Dresden Nuclear Power Station, Units 2 and 3  
Facility Operating License Nos. DPR-19 and DPR-25  
NRC Docket Nos. 50-237 and 50-249

Quad Cities Nuclear Power Station, Units 1 and 2  
Facility Operating License Nos. DPR-29 and DPR-30  
NRC Docket Nos. 50-254 and 50-265

Subject: Revision to Proprietary Designation - Additional Plant Systems Information Supporting the License Amendment Request to Permit Uprated Power Operation, Dresden Nuclear Power Station and Quad Cities Nuclear Power Station

**Attachment C**  
**Additional Plant Systems Information Supporting the License Amendment**  
**Request to Permit Uprated Power Operation (Non-Proprietary)**  
**Dresden Nuclear Power Station, Units 2 and 3**  
**Quad Cities Nuclear Power Station, Units 1 and 2**

Figure 9-1  
DNPS Short Term Core Spray NPSH

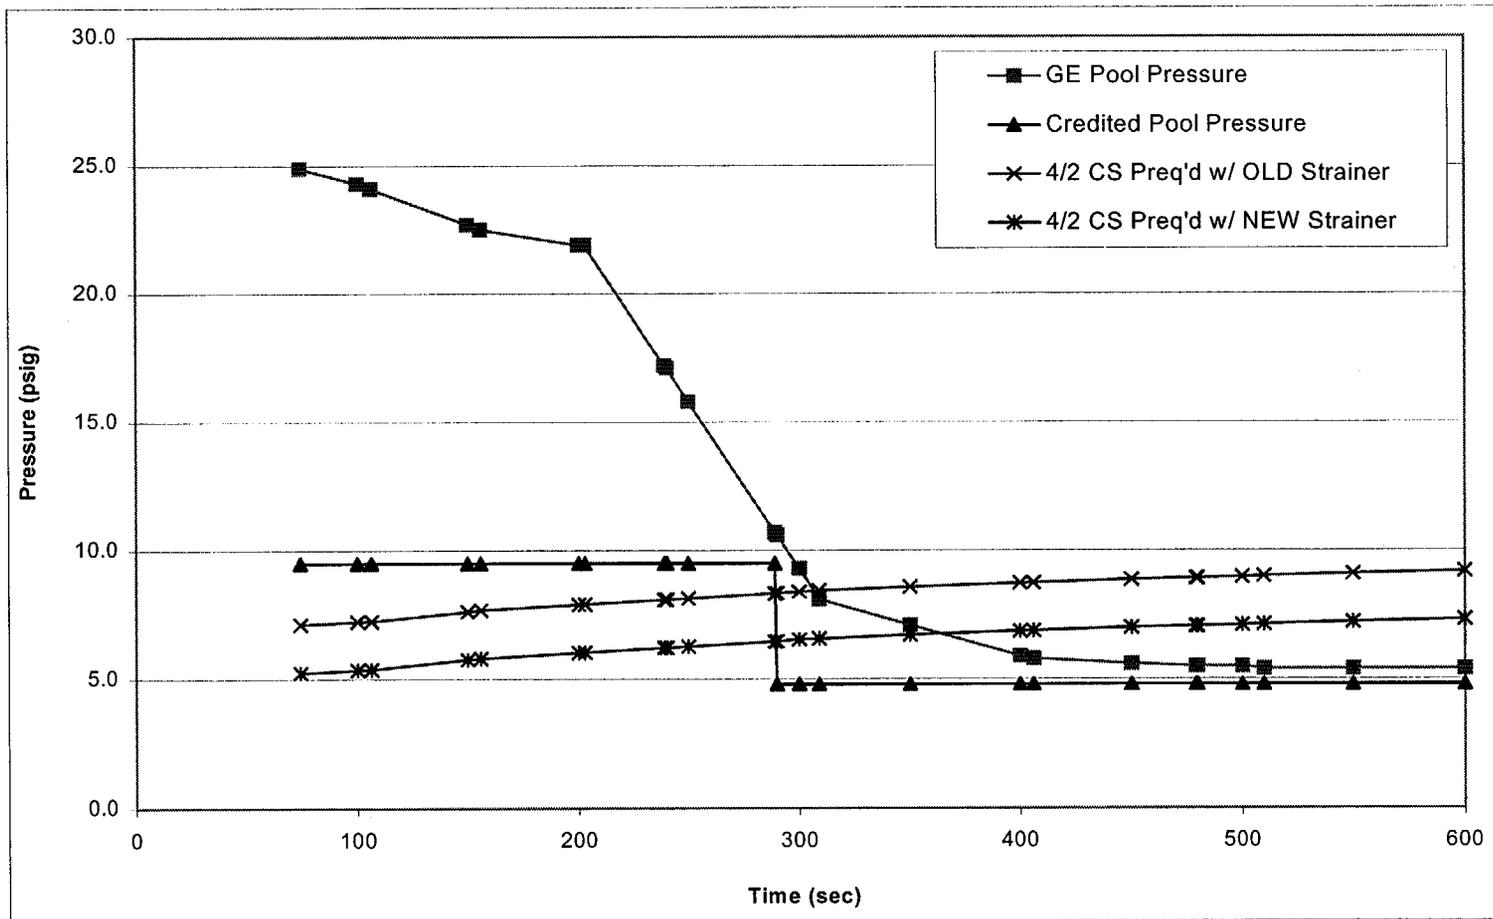
*9. Provide the emergency core cooling system (ECCS) pumps net positive suction head (NPSH) calculations to support the requested additional credit for overpressure. Discuss the increased need for containment overpressure for NPSH following a design basis accident. Describe the procedures or equipment in place that will allow continued cooling flow with the drywell potentially depressurized to atmospheric conditions and the suppression chamber at the most conservative pressure associated with vacuum breaker operation (limiting case either torus/drywell or torus/reactor building). Additionally, discuss the methodology for determining the requested containment overpressure, including the headloss across the ECCS suction strainers.*

The graphs showing the results of the ECCS NPSH calculations for the limiting short term and long term flow cases are provided in Figures 9-1 and 9-2. Core spray flow is the limiting NPSH case in the short term, and LPCI flow is limiting for NPSH in the long term. Figures 9-1 and 9-2 also show NPSH required (NPSHr) for both the old strainer and new strainer cases (e.g., one blocked, three clean). The higher head loss of the old strainers, as indicated above, is the basis for the requested overpressure.

In the short term, there is a period from approximately 290 seconds to 600 seconds during which some ECCS pump cavitation can occur, since the available NPSH is less than the required NPSH. This period is after the time at which the peak cladding temperature (PCT) has been reached at approximately 240 seconds. Prior to 290 seconds, the requested overpressure ensures that adequate NPSH is available to meet the core cooling requirements assumed in the PCT calculations. After 600 seconds, ECCS pump throttling restores adequate NPSH. Pump cavitation for the brief time from 290 seconds to 600 seconds is not of concern due to short duration of the cavitation.
